Outer Dowsing Offshore Wind

The Applicant's Responses to The ExA's Second Written Questions

Deadline 4a

Document Reference: 21.2

Figure 1.14 Q2 LU 1.1

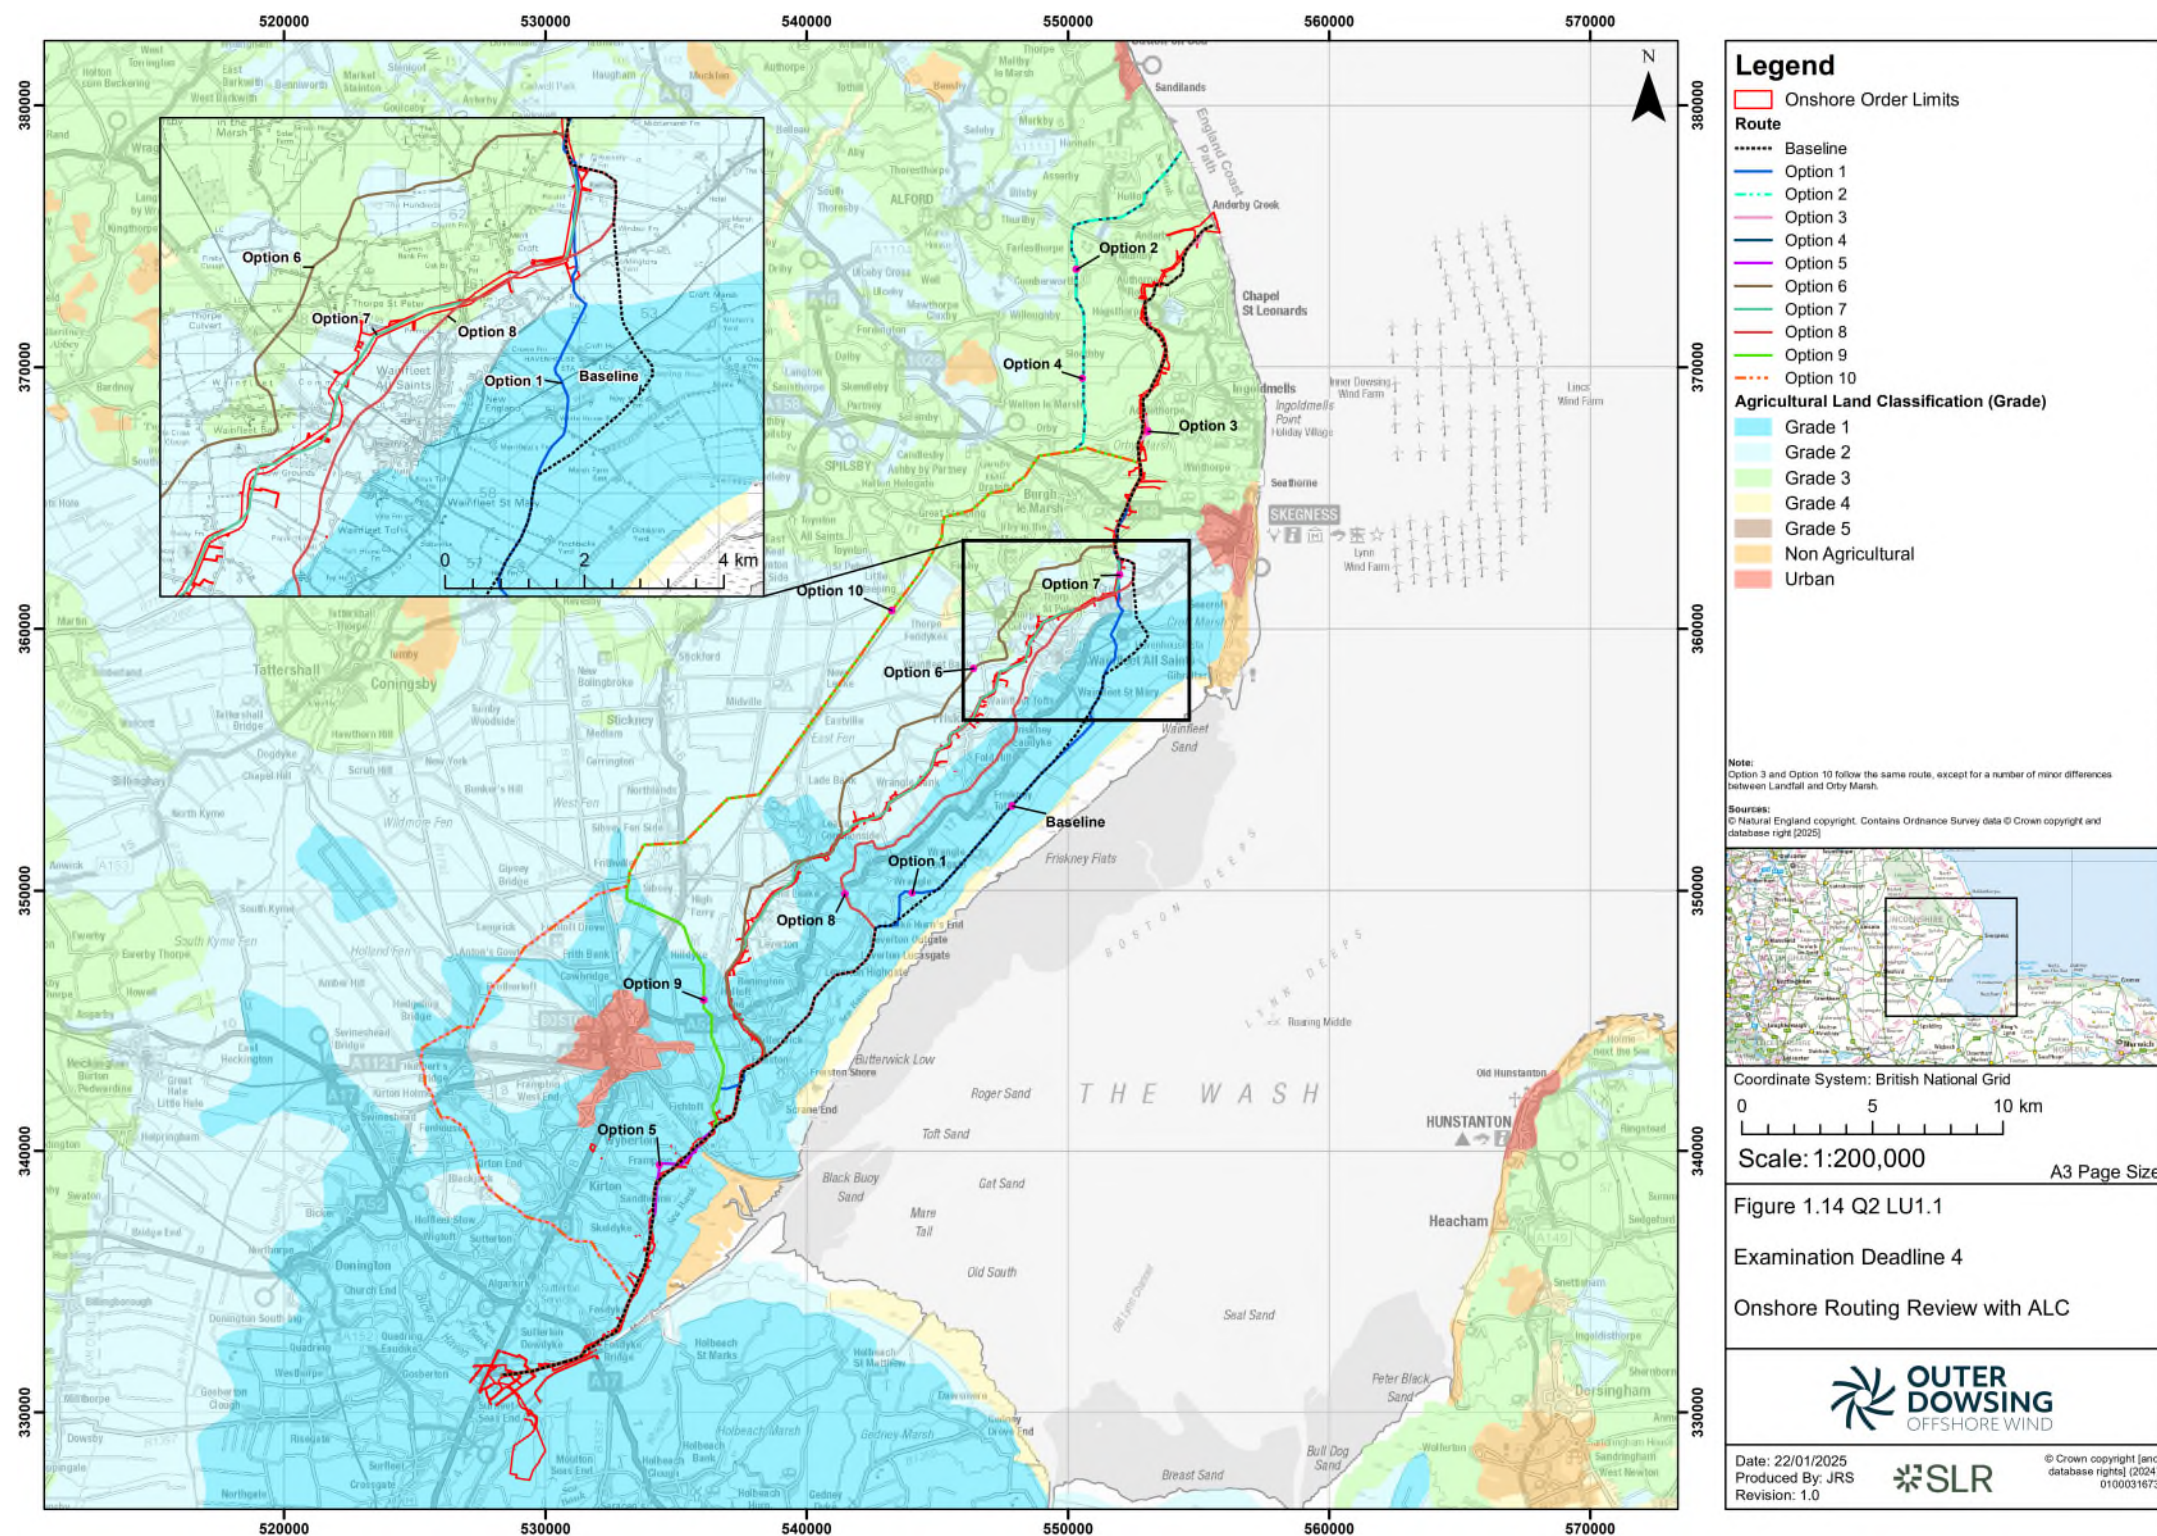
Question ID	Question addressed to	Question	Response
Q2 LU 1.1	The applicant T.H. Clements & Son Ltd	Onshore Export Cable Corridor (ECC) alternatives - Agricultural Land Classification (ALC) In response to ExQ1 LU 1.2 [REP2-051], the applicant provided appendix 1.14 which provides a plan of route options and a table of predicted ALC grades. In addition, the weighting of the options is also presented in response to matters raised in T.H. Clements & Son Ltd’s Relevant Representation [RR-067]. • Can the applicant clarify why table 1.14 shows both option 2a and option 2A? • T.H. Clements & Son Ltd is invited to respond to the information presented by the applicant.	The Applicant wishes to apologise to the examining authority for the confusion caused by this labelling errors that was not captured prior to submission. To rectify this error the applicant has re-labelled all routes on the map and table to provide further clarity and reduce confusion. Revised versions of Figure 1.14 Q1 LU 1.2 and Table 1.14 Q1 LU 1.2 are provided in Appendix 2.12.
